CHARTER TOWNSHIP OF MERIDIAN  
ZONING BOARD OF APPEALS MEETING AGENDA  
5151 MARSH ROAD, OKEMOS, MI 48864-1198  
(517) 853-4000  
WEDNESDAY, MARCH 9, 2016 6:30 PM  
TOWN HALL ROOM

1. ZBA CASE NO. 16-03-09-1 O'REILLY AUTO PARTS, 233 SOUTH PATTERSON, SPRINGFIELD, MO 65802

RE: ZBA Case No. 16-03-09-1

**REQUEST TO ALLOW A  
FREESTANDING SIGN TO  
EXCEED MAXIMUM  
ALLOWED SIZE OF 25 SQ. FT.  
AT 2703 GRAND RIVER AVE.  
(O'REILLY AUTO PARTS STORE)**

① Pole Sign  
Scale: 3/8" = 1'-0"

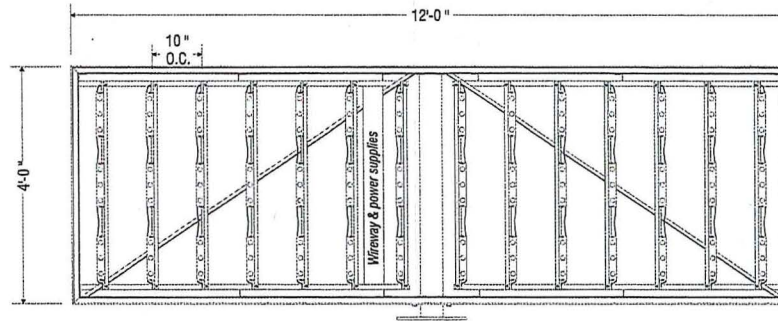
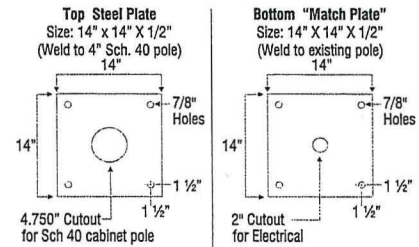
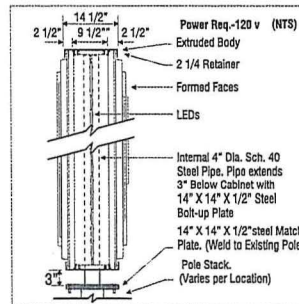
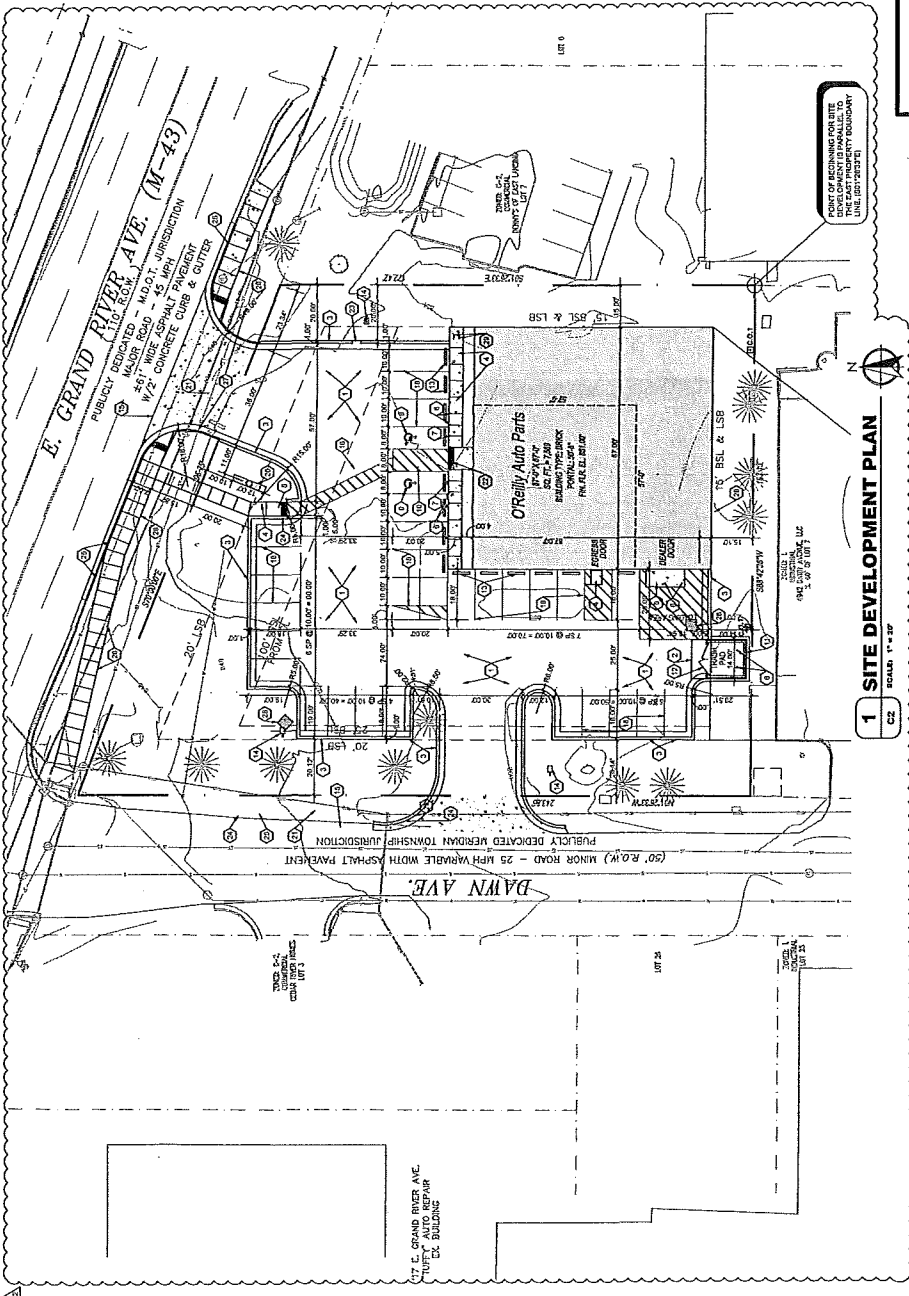
The proposed freestanding sign is shown on the west side of the entrance drive off Grand River Avenue. The sign meets the required 10 foot setback from the street right-of-way of Grand River Avenue, and is outside of the sight triangle. The 16-foot tall pole sign has a cabinet that measures four feet in height and 12 feet in width, for a total size of 48 square feet of surface display area per side. Per Section 86-687(4)d. a freestanding sign taller than five feet in height shall not exceed 28 square feet in surface display area.

Section 86-687(4)f. requires three square feet of the freestanding sign to accommodate the street number of the structure (business), thus the allowed surface display area for the business name portion of the freestanding sign is 25 square feet. The proposed sign does not include a street address.

The applicant is requesting to construct a freestanding sign that exceeds the maximum allowed size of surface display are. The request is summarized below.

<b>ALLOWED SIZE (sq. ft.)</b>	<b>PROPOSED SIZE (sq. ft.)</b>	<b>VARIANCE REQUEST</b>
Freestanding sign	25 sq. ft.	48 sq. ft.	23 sq. ft.

A street address will be required to be included on the freestanding sign as part of the building permit for the sign.
